**Re: Second Submission Review** – Green Valley Ranch East Site Plan No. 5 - Site Plan Amendment No. 2 Minor Site Plan Amendment and Plat

Application Number: **DA-1662-23**

Case Number(s): 2019-4022-02; 2021-3047-00

H1

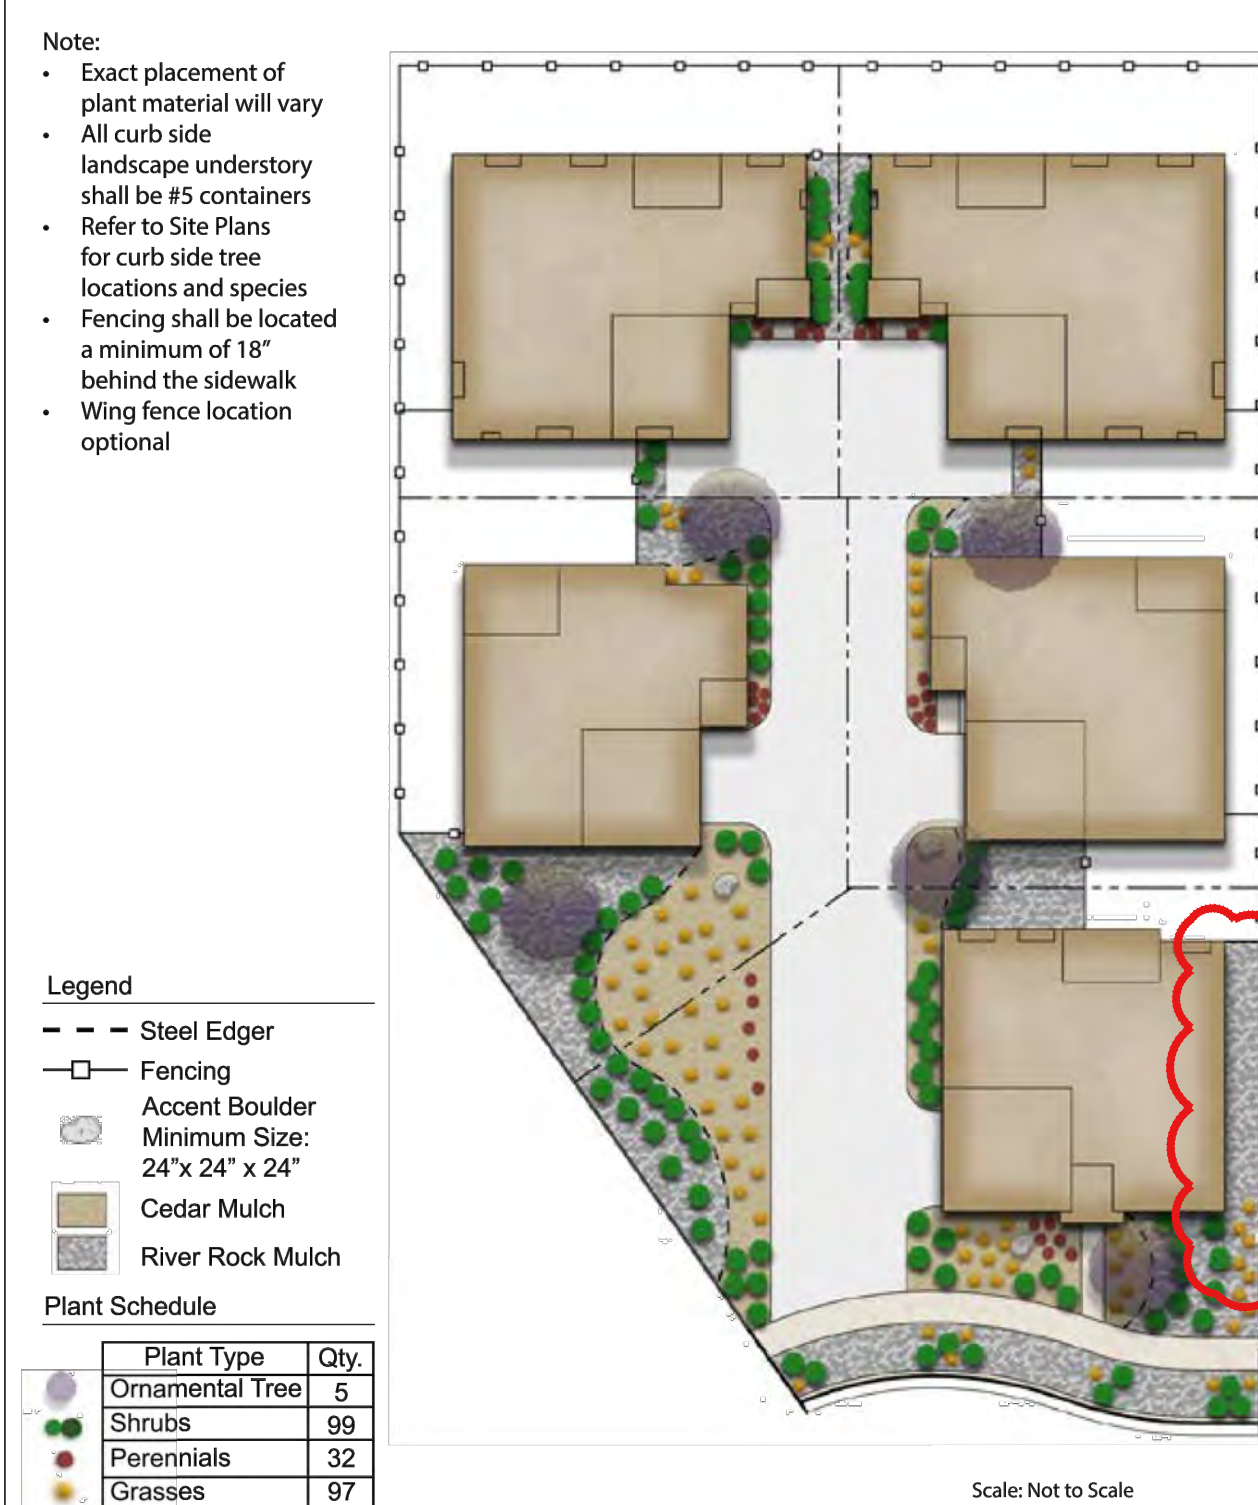
- SHIFTED WING FENCES AND REDUCED SIDE LOT FENCING  
 - H1 WING FENCES HAVE SHIFTED AND PLANTING HAS BEEN ADJUSTED TO FOLLOW FENCE LINE  
 - WING FENCE NOTE ADDED
